Historic District Commission Meeting

7:00 PM - Tuesday, May 10, 2022
Ypsilanti Freighthouse

HDC Work Permit Staff Review

Property address: 202 E Forest

2 TYP. RAMP SECTION
SCALE 1" = 1'-0"

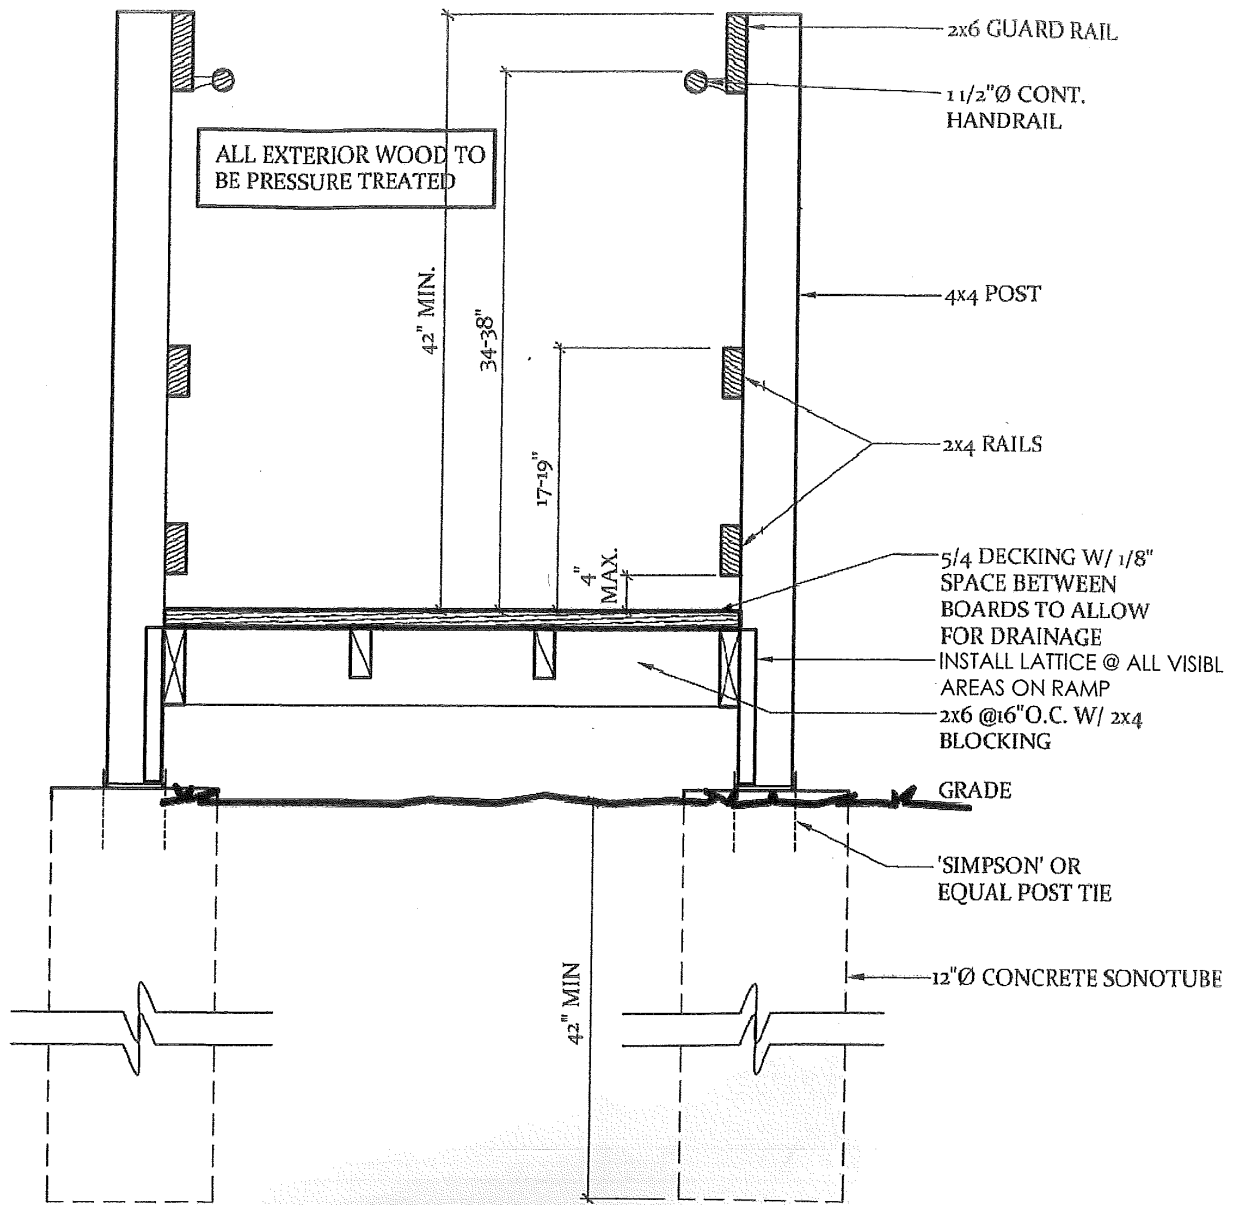
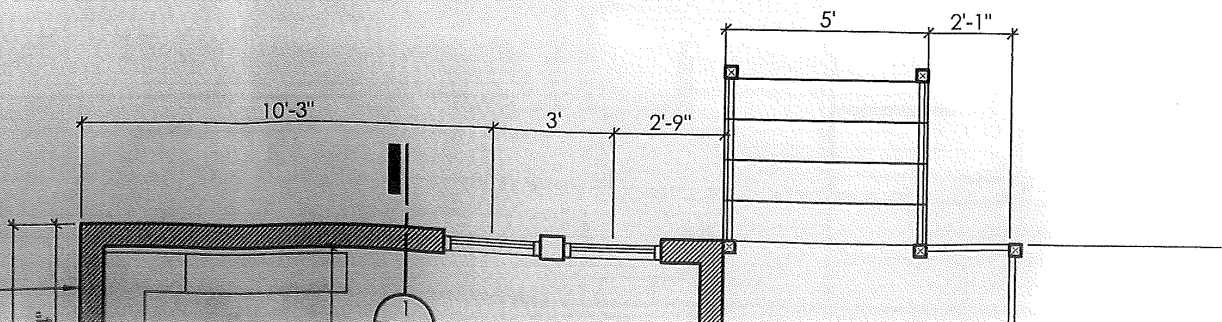
1. Handicapped-accessible ramp to be added to the house's front porch meets the Secretary of the Interior's Standards, staff believes, since it leaves the historic porch intact, does not diminish its historic character, and if it were removed, the historic house would be unaffected. (Standards 2, 5, 9, and 10)
2. Rear porch is likely original to the house. Its lower portion was re-sided when the house was re-sided, but its simple frieze and columns appear to be historic and match those of the front porch. Demolishing it likely does not meet the Secretary of the Interior's Standards for Rehabilitation. (Not meeting Standards 2, 5, 6)
3. The proposed addition, in staff's opinion, meets the Secretary of the Interior's Standards because it is

4. The ramp to be built onto the new addition also meets the Secretary of the Interior's Standards, staff believes, because it is compatible with the house's historic materials, size, and scale, and if it were to be removed, the historic house would be unaffected. (Standards 9 and 10)
5. Before proceeding with work, applicant must seek the appropriate building department permits.

In addition, I move to issue a certificate of appropriateness for the handicapped-accessible ramps as proposed April 21 for 202 E Forest because they meet the Secretary of the Interior's Standards for Rehabilitation, specifically Standards 2, 5, 9, and 10.

330 E. Forest Ave.-Current Fence to be replaced

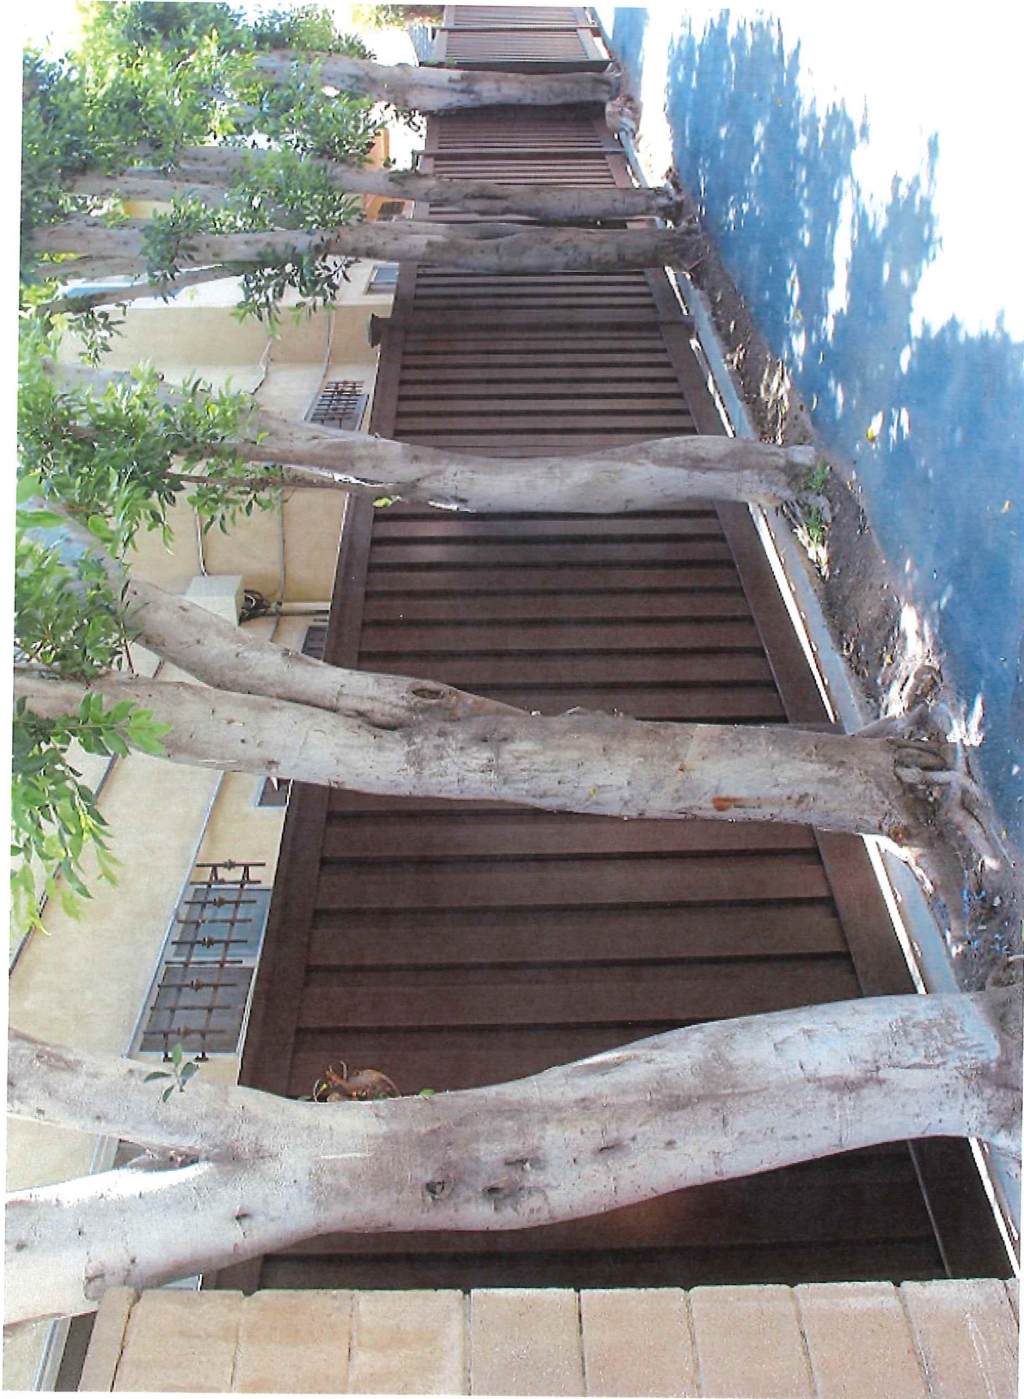
1. The proposed fence is the same height as the existing fence.
2. The existing fence is wood in brown; the proposed fence is a wood composite in brown.
3. The existing fence is either a stockade-style or dogear-style fence. The proposed fence is made up of panels, so the top of the fence is straight across.
4. Before proceeding with work, applicant must seek the appropriate building department permits.

Move to issue a certificate of appropriateness for the work at 330 E Forest proposed April 22, 2022 for the removal and disposal of the existing fence and installation of 6' composite

Window 11

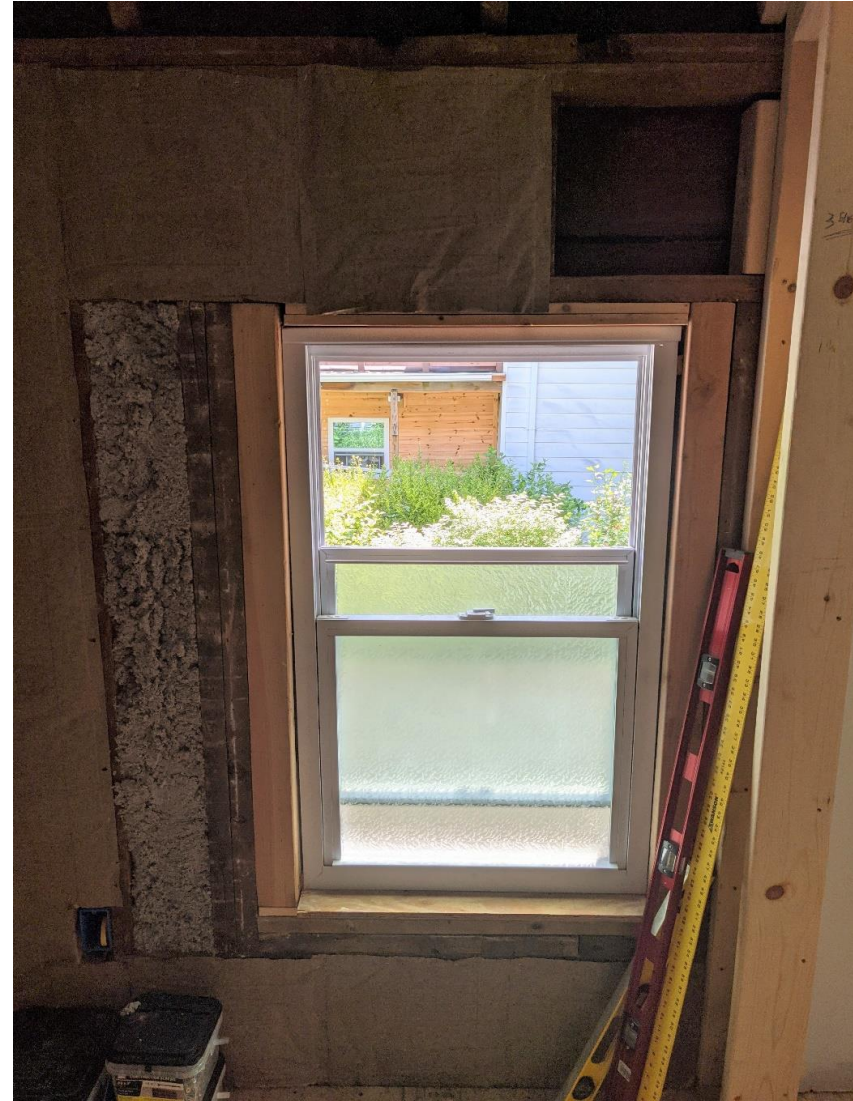
2. If wood windows will remain, storm windows (these or others approved by the commission) would be recommended to protect the windows.
3. VINYL WINDOWS: Of the 11 windows that are proposed to be replaced, two are vinyl. Staff believes the proposed one-over-one double-hung wood windows clad in aluminum would meet the Secretary of the Interior's Standards as a replacement for vinyl—a non-historic material. Staff believes the proposed windows to replace these two vinyl windows meets Standard #9.

4. WOOD WINDOWS: The applicant prepared a preliminary wood window conditions assessment and included it with the application, and staff found this helpful but still had further questions about conditions. Old-growth wood windows are extremely valuable and a very limited resource. The Secretary of the Interior's Guidelines for Rehabilitation state, "Not recommended: Replacing windows solely because of peeling paint, broken glass, stuck sash, and high air infiltration. These conditions, in themselves, are no indication that windows are beyond repair." Staff would recommend a conditions assessment completed by a window restoration professional to fully understand which windows are historic, which can be repaired and weatherstripped, and which are beyond repair and must be replaced. Historic windows that have been repaired, weatherstripped, and outfitted with a storm window, can be about as efficient as new windows and will likely last much longer than new wood windows.
